Re: Turkey Point Units 3 and 4
Docket Nos. 50-250 and 50-251
Response to Request for Additional Information for the
Review of the Turkey Point Units 3 and 4
License Renewal Application

ATTACHMENT 1
RESPONSE TO REQUEST FOR ADDITIONAL INFORMATION
DATED FEBRUARY 1, 2001 FOR THE REVIEW OF THE
TURKEY POINT UNITS 3 AND 4,
LICENSE RENEWAL APPLICATION

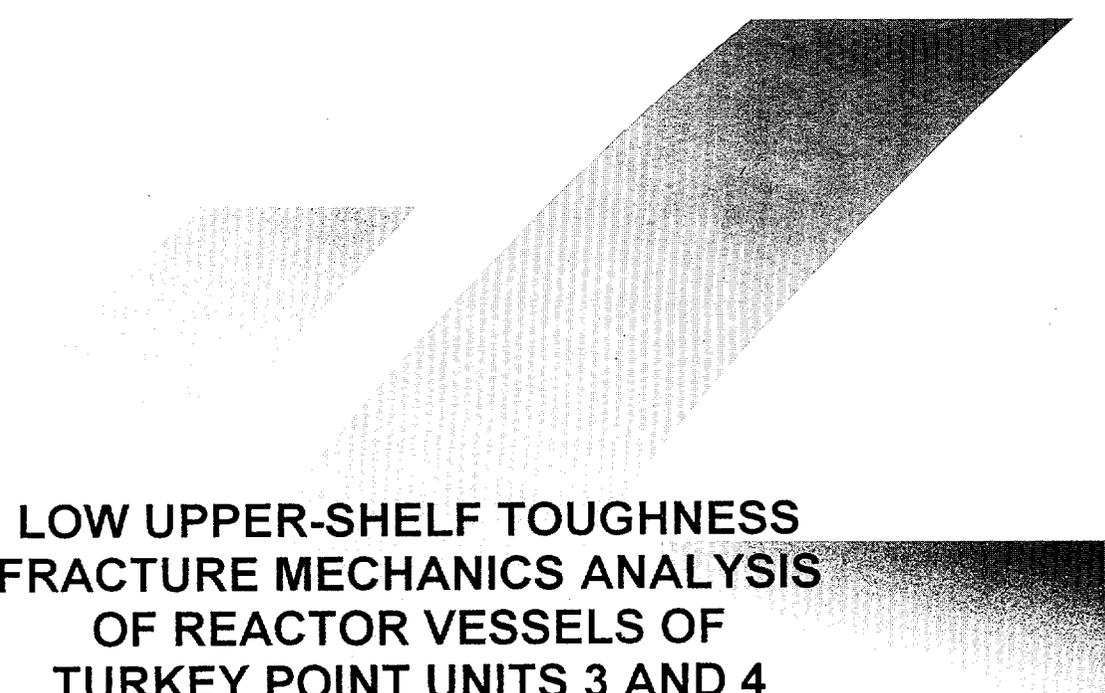
The submittal indicated that, in response to NRC Bulletin 88-09, eddy current test inspections of thimble tubes in Units 3 and 4 were conducted in the early 90's, and tube wall wear rates were established in both units. Based on these wear rates and the time-limited aging analysis (TLAA) results, only a single tube (#N-05 in Unit 3) will require inspection for the extended operation. Identify the wear rates and describe the TLAA processes and results, including assumptions used and analysis results to justify that the acceptance criterion of 70% wall loss are met for extended operation of all thimble tubes except the tube #N-05 in Unit 3. Note that the wear rate may increase with time when flow-induced thimble tube vibrations become more severe due to increased wear. TLAA based on previous inspection results obtained in early 1990's may not be realistic without verification. Confirm that an evaluation was performed in the TLAA to ensure adequate coverage of potential uncertainties in wear rates.

- Wall loss of up to 80% is acceptable (70% was used).
- Eddy current testing is considered accurate to a $\pm 10\%$ margin.
- Wear rate follows a decreasing exponential curve.
- Each thimble tube has a unique wear rate.
- Only thimble tubes with greater than 23% wall reduction need be considered.
- No wear is assumed for other than full power operation.

Based on the above assumptions, the following equation was utilized to determine the number of years to reach 70% through wall on any tubes currently with greater than 23% through wall.
